1998-00
ACCORD

99-088

Loose or Broken Temperature and Fan Control Knobs

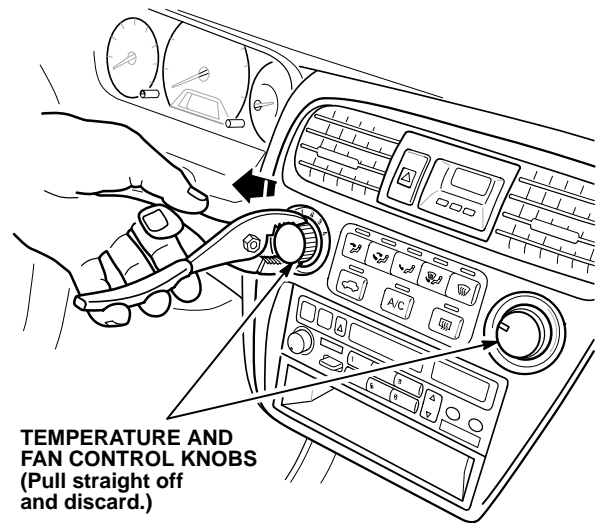
Residual grease from the switches can deteriorate the plastic of the control knobs, causing the control knobs to crack or break.

1. Remove the old or broken temperature and fan control knobs with a pair of pliers.

NOTICE To avoid damaging the center panel, do not pry off the knobs.

2. Clean both switch shafts with denatured alcohol; make sure you remove all grease from the shafts.
3. Install the new control knobs.

Clean the switch shafts with denatured alcohol or other non-petroleum-based cleaner, and install the new control knobs.

Temperature and Fan Knob Set: P/N 79581-S84-999
